**Comments on Proposed Interim Staff Guidance COL/DC-ISG-003**

### **AREVA NP Comments on Proposed Interim Staff Guidance COL/DC-ISG-003, "Probabilistic Risk Assessment Information to Support Design Certification and Combined License Applications"**

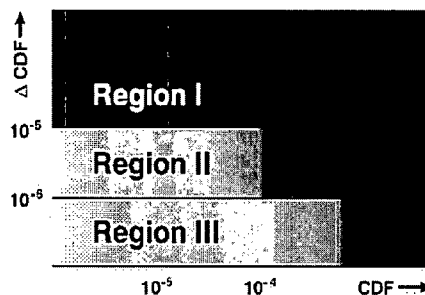
The significance criteria currently used in the risk-informed application is defined in Regulatory Guide (RG) 1.174 as illustrated on the figure below, and summarized in "calculated increase in CDF is very small, which is taken to as being less than  $1\text{E-}6/\text{yr}$ ..."

The proposed 5% significance criterion proposed in COL/DC ISG-003 will likely lead to different conclusions than the RG 1.174 significance criterion.

In addition, a definition of a significant change on the order of  $1\text{E-}8/\text{yr}$  would have little meaning given the typical uncertainty ranges.

For the small CDF and large release fraction values (LRF) for new ALWR plants, AREVA NP suggests the following criteria as better measures of significance:

RG 1.206, Section C.III.1 addresses the COL applications that reference a design certification. Any individual important change or departure from the design that results in a significant impact on the PRA quantitative results or PRA qualitative results should be reported to the NRC based on the following criteria:

The change in the CDF either positive or negative:

- Greater than 25%: Report
  - 5% through 25%: Report if larger than  $1E-7$ /yr for CDF or  $1E-8$ /yr for LERF
  - Less than 5%: No need to report
2. Proposed Interim Staff Guidance, Point 9 (page 9) should be revised to align with 10 CFR 50.71(h). PRA updates should "cover initiating events and modes of operation contained in NRC-endorsed consensus standards" rather than "reflect" which could imply more scope changes than those implied by the requirement.
